**CITY OF BEAUFORT
DESIGN REVIEW BOARD
Staff Report
Meeting of January 15, 2015**

Case Number: 15-01 DRB.1
Project: Parker’s Convenience Store & Gas Station
Property Address: 3462 Trask Parkway
Parcel #: R120-025-000-0012-0000 & R120-025-000-012C-0000
Zoning: Highway Commercial
Design District: S.C. Highway 170 District
Type of Review: **Conceptual Review – New Construction**

**PARKER'S CONVENIENCE
CITY OF BEAUFORT, SOUTH CAROLINA**

**Project Narrative
J – 24234.0010
December 30, 2014**

ILLUSTRATIVE SITE EXHIBIT OF

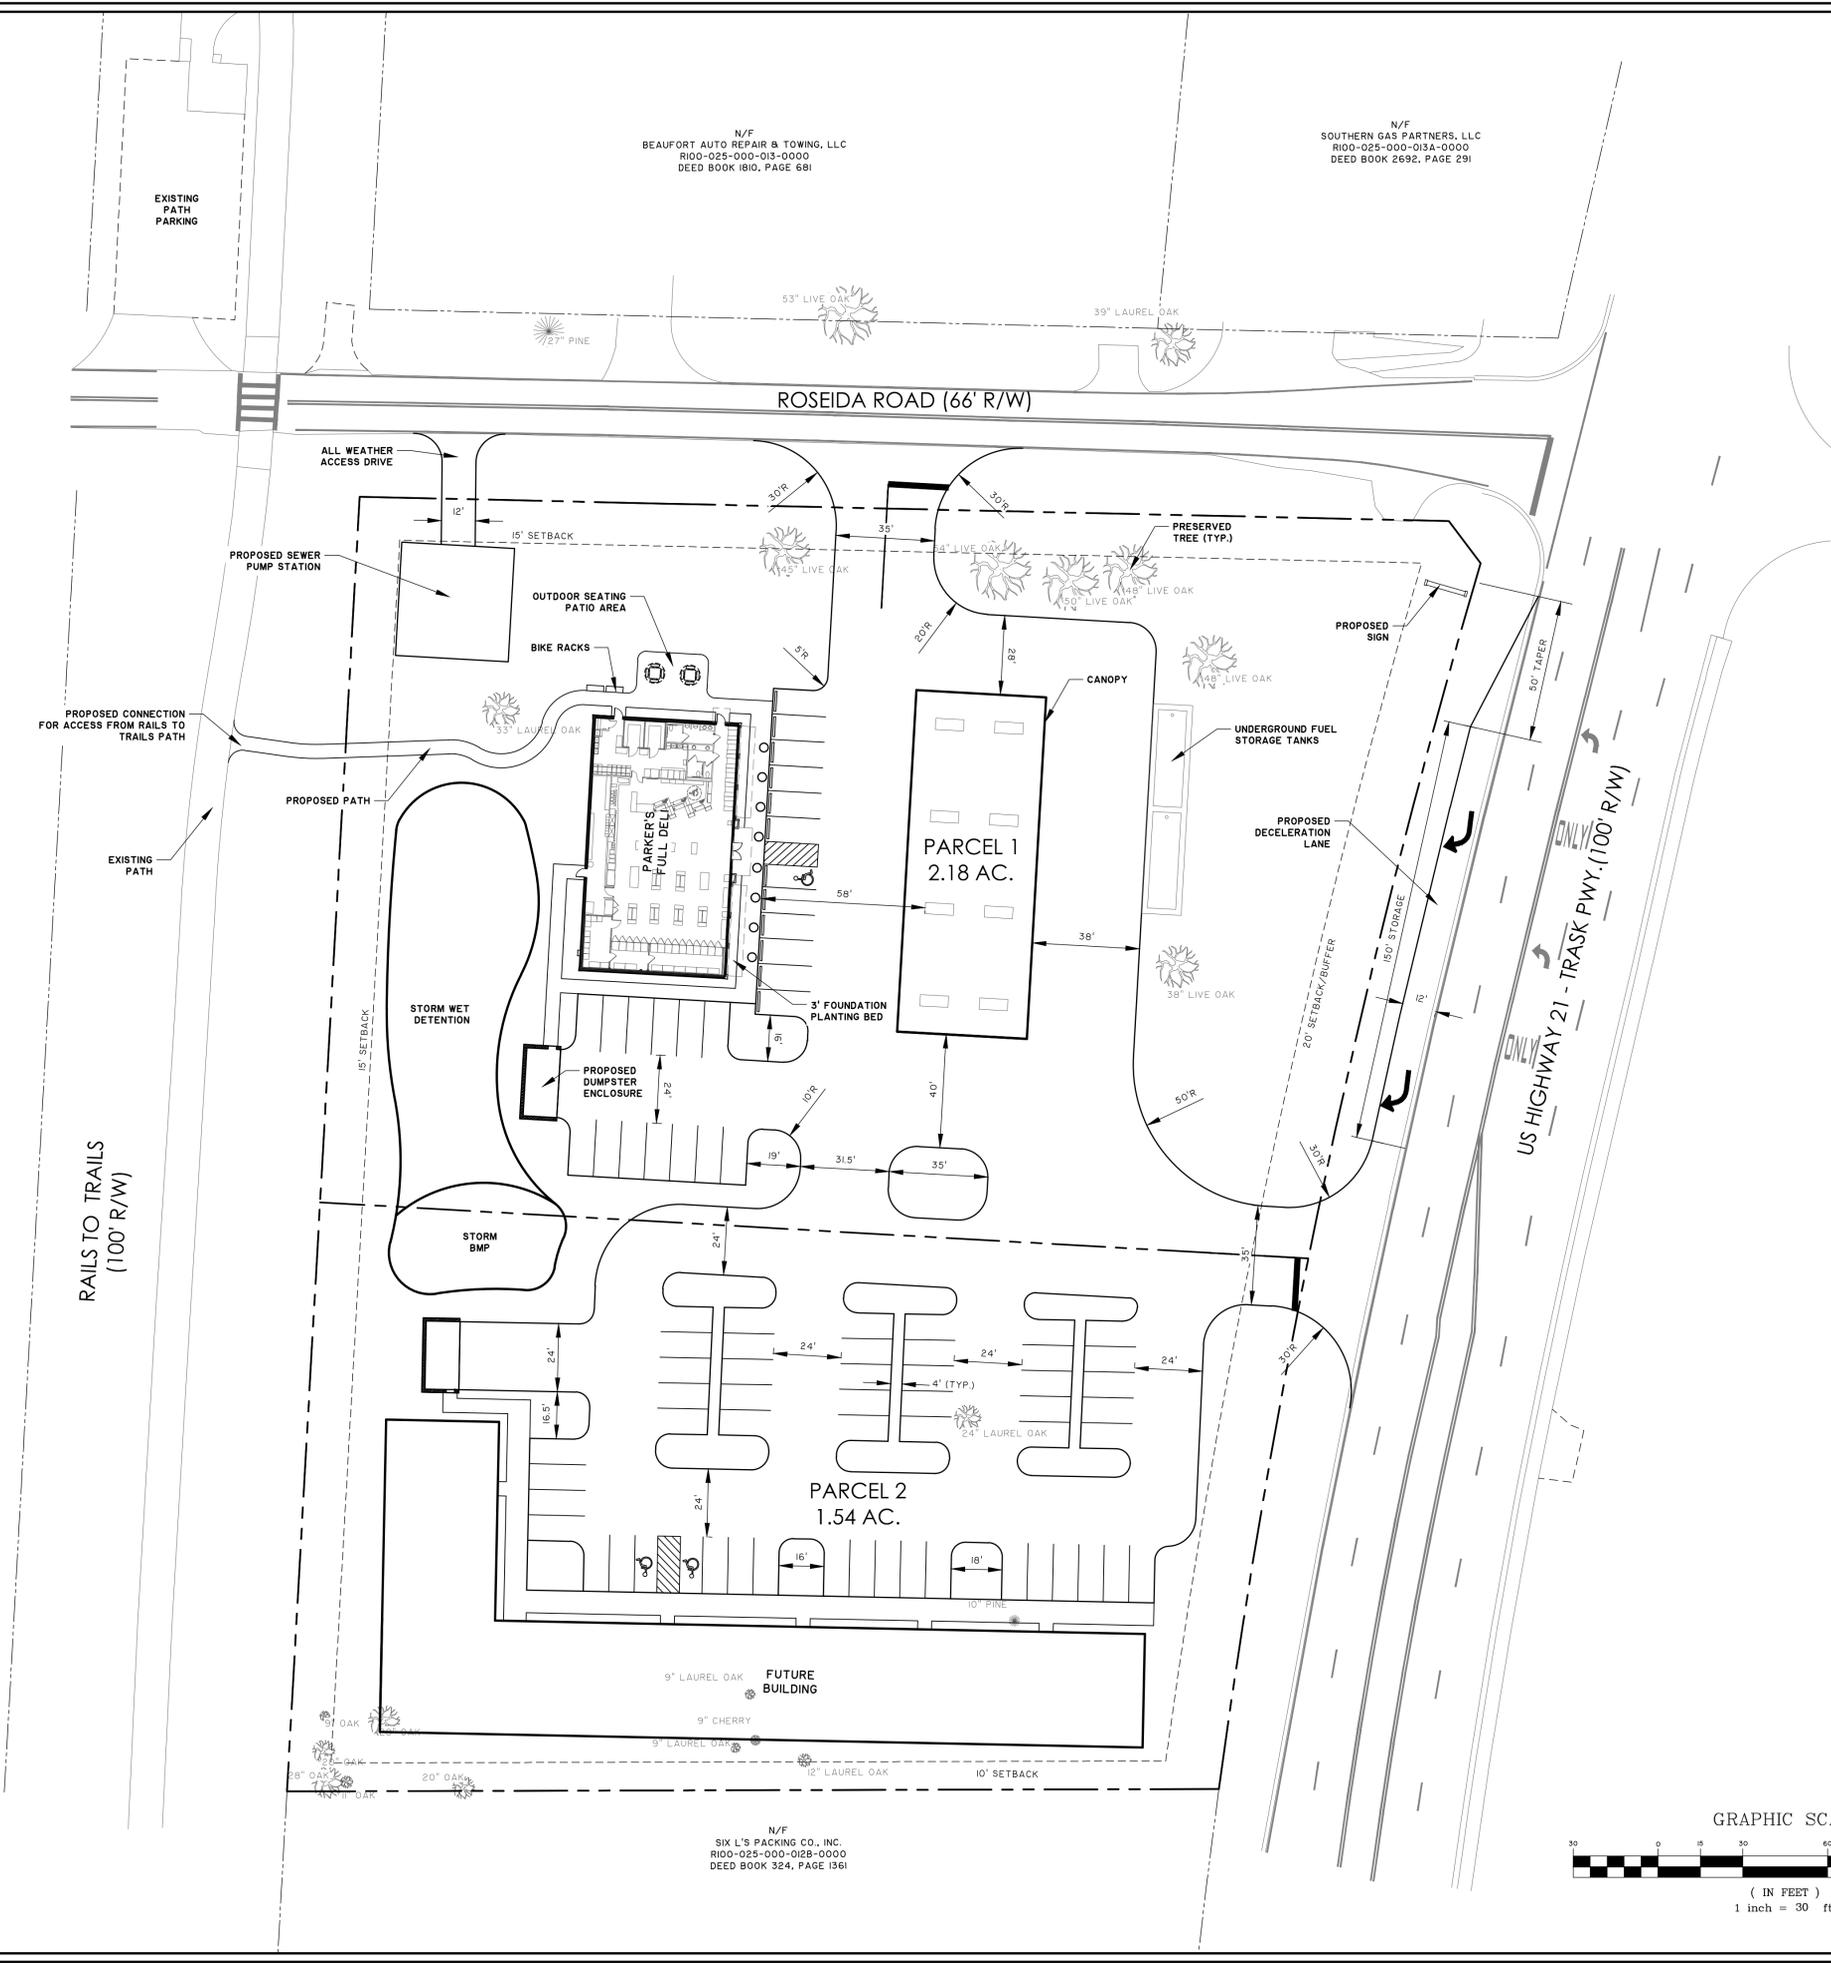
- This site plan does not meet the intent of the UDO. However, given the rural location, surrounded mostly by low-density unincorporated Beaufort County property, it is worth considering an alternative site design if it is appropriate.

- The location of the building closer to the Spanish Moss Trail has a positive benefit to trail users. Adding more seating/plaza area closer to the trail, perhaps under the 38” Live Oak, could strengthen this connection.

- Trees: The location of the fuel pumps and structure to avoid the existing large trees on the north and eastern portion of the property is appreciated.

- Both of the above trees will be significantly affected by installation of underground tanks in location as currently shown. Can they be relocated beneath pavement on interior of drive area?

- Given the lack of effective screening by these trees, staff recommends the DRB consider asking the applicant install a low wall or fence along the Highway 21, and

- The location of the underground tanks should be rethought as per landscaping comments above, as well as to screen them from US 21.
- The shared access point on US 21 along the future property subdivision line is appreciated and complies with the recommendations of the UDO.

- With regards to the Future Building, the configuration of this structure should be rethought to minimize the amount of parking in the front, as per the UDO Section 6.6 requirements.

- Given the location of the stormwater pond and the visibility from the rail trail which is a public right of way, this pond should be treated as an amenity as per the UDO Section 6.6.

- Is it possible to move the pump station internal to the property so it is not located on the corner? Understanding that BJWSA access is an issue, it appears that it could be moved where the Storm BMP is shown and accessed via the paved parking area.

Staff recommends that the DRB give conceptual approval to the plans as submitted, and recommends that the ZBOA grant a variance contingent on some of the site-related items discussed above namely: relocating the pump station and better integrating into the trail; installing a low wall or fence around the perimeter; location of the storage tanks; and an arborist report listing that the trees proposed to be retained are the species indicated and in good health as they provide a buffer between the pump station and the street.

DEMOLITION AND
TREE REMOVAL EXHIBIT
PARKER'S CONVENIENCE STORE
CITY OF BEAUFORT

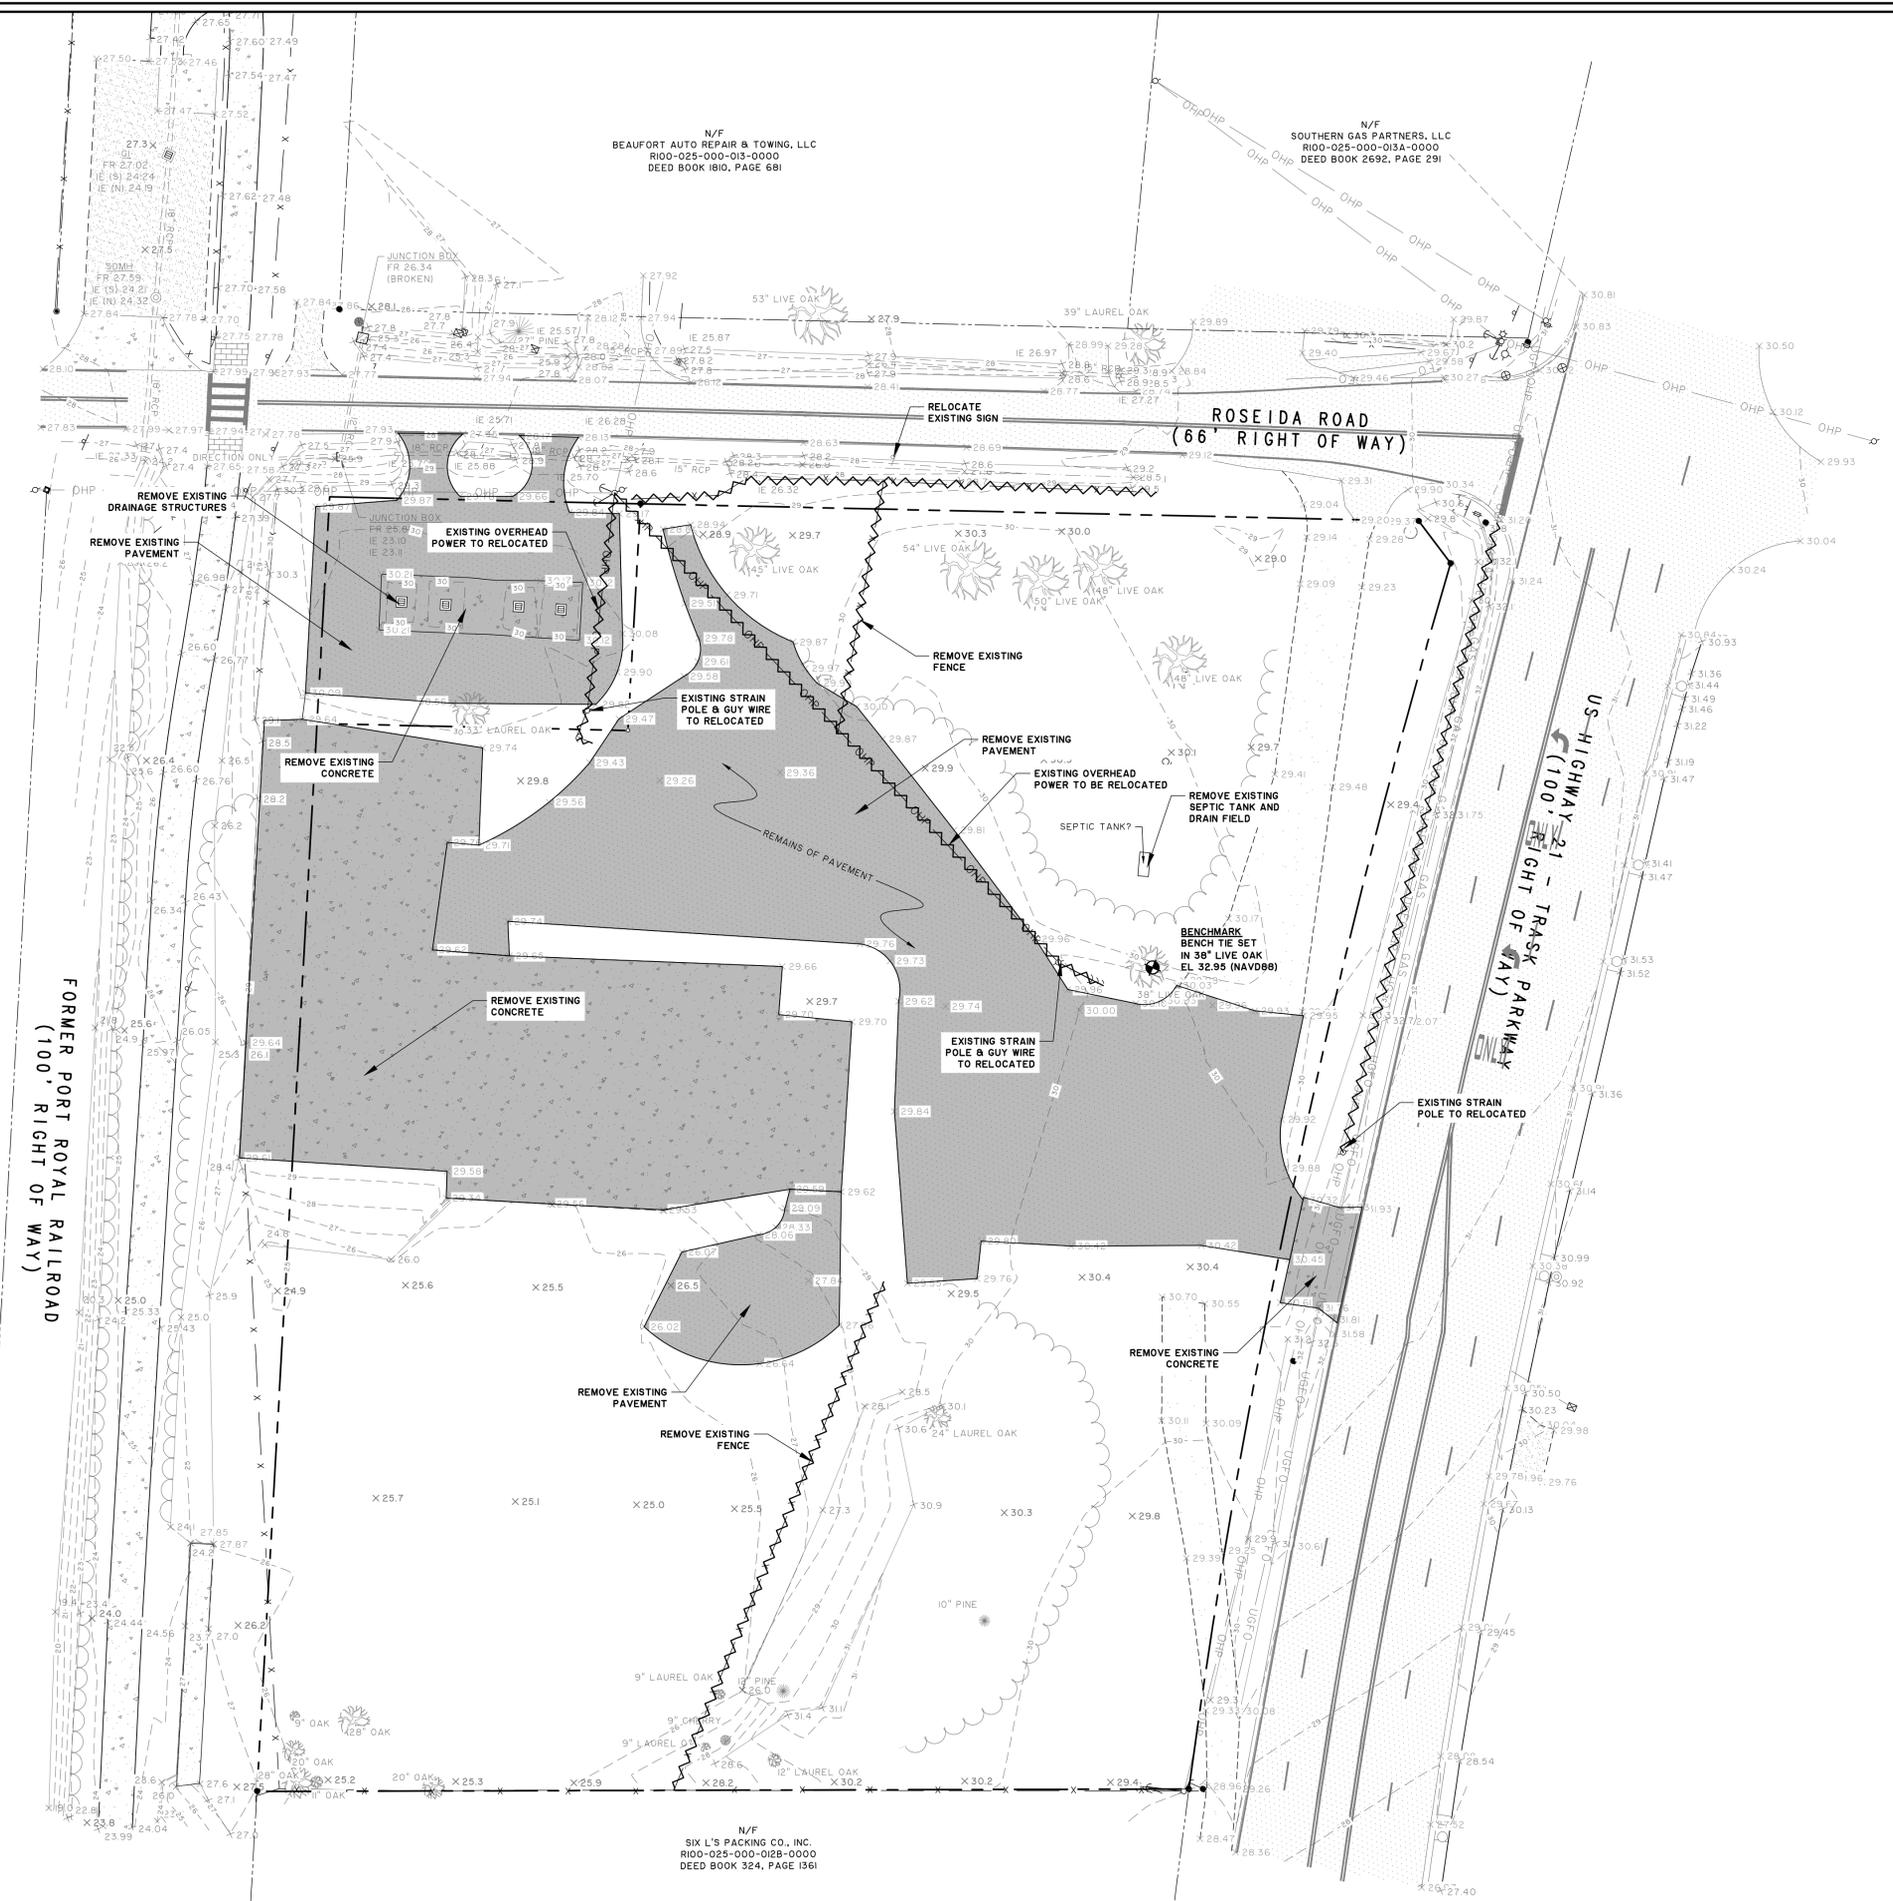
- An arborist report will be required for all trees, both saved and removed, that will be impacted by development. Upon inspection by the city arborist she determined the following:

- 38” Live oak nearest Hwy. 21 entry to station is a Laurel oak. Its co-dominant, in moderate health. Arborist assessment is required. Could not see if cavity exists at juncture of co-dominant stems. Also too much undergrowth to assess base of trunk. Distance to edge of canopy on south and east side is 30’; west side of tree 18’; very little canopy on north side. In my opinion, effectiveness of screening for pumps is minimal.

- 45” Live oak shown to right side of pumps: tree leans to the south; canopy spread to south/southeast is 40 to 50’ but pruning of lower limbs most likely will be needed for vehicular clearance over drive. Not a lot of canopy on north side of tree. Tree in good health but again, screening may not be very effective.

- The three trees shown along Roseida are Live oaks in good health (54”, 50” and 48”). Canopy spread extends over Roseida. Raising of canopy on south side of these trees (pump area) will most likely be required for vehicular clearance. Could not get close to trees due to underbrush. All require significant deadwood pruning.

- All trees should be assessed by certified arborist. All will require root pruning and fertilization. Distance of curb to leading edge of root flare to be a minimum of 3 times the caliper. In the case of the 54” Live oak, this distance is probably 15 and 20 feet.

1
A3.3 OVERALL FRONT ELEVATION - GAS CANOPY (SHOWN FOR PRESENTATION ONLY)
SCALE: 1/8" = 1'-0"

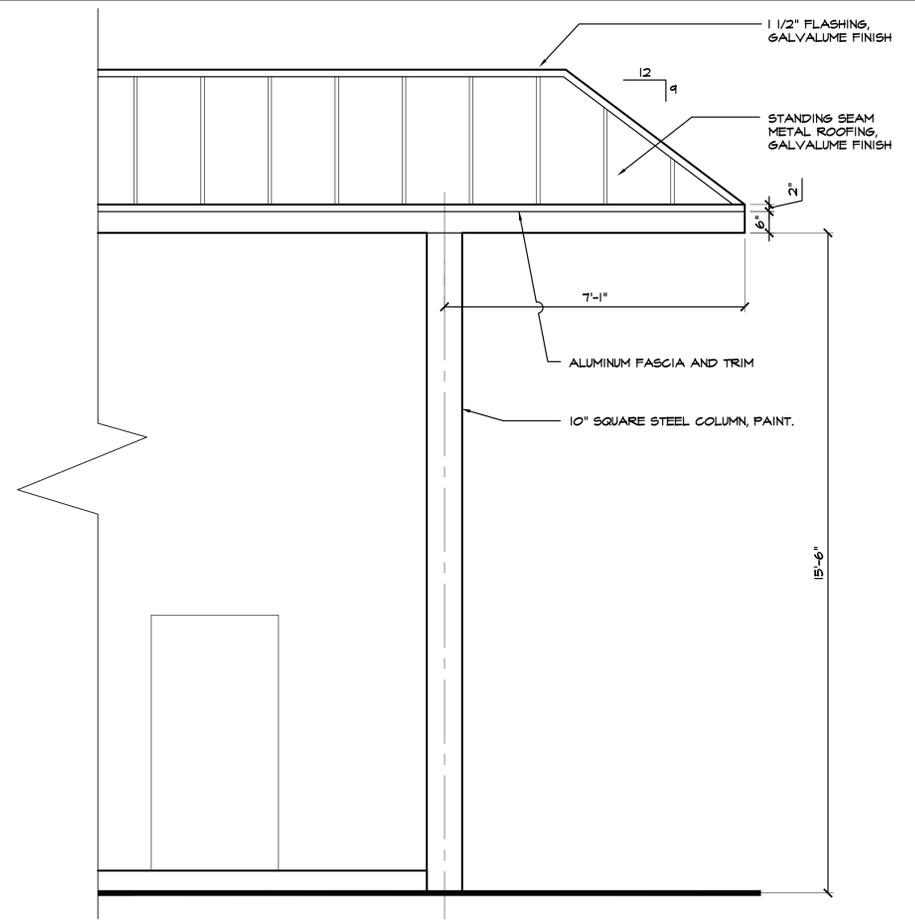
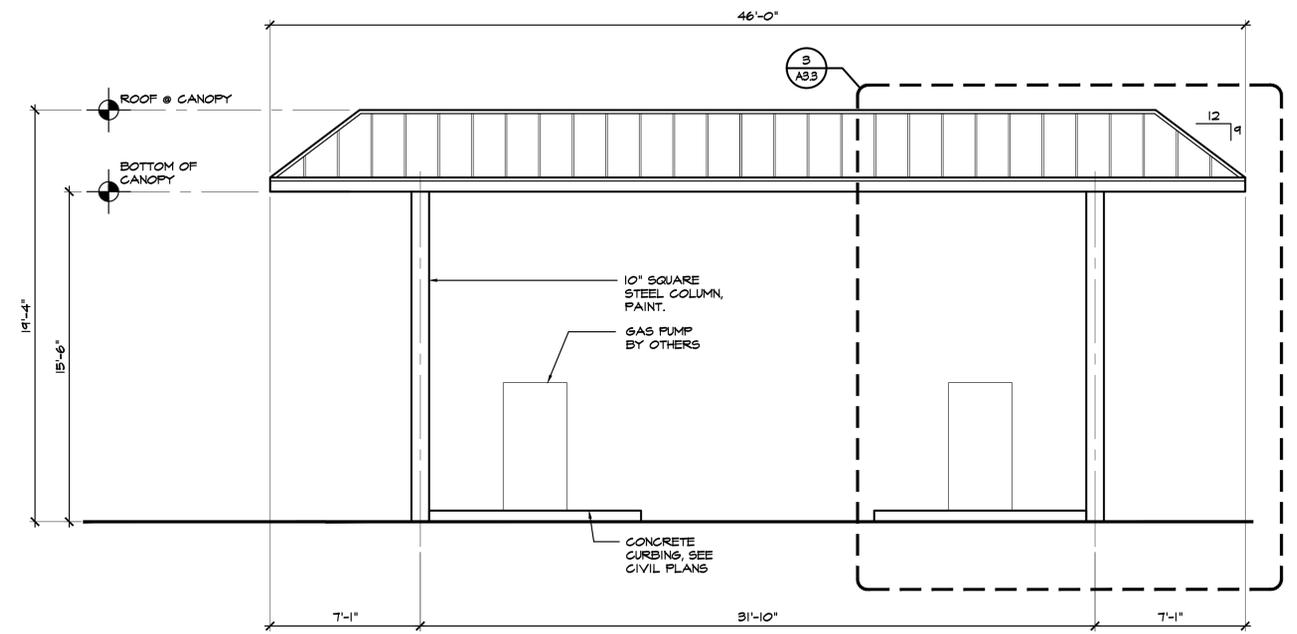
- Staff appreciates the lowcountry vernacular detailing that has been applied to this project and feels that it is appropriate for this area of the city.
- Staff appreciates the pitched canopy proposed for the pump station.
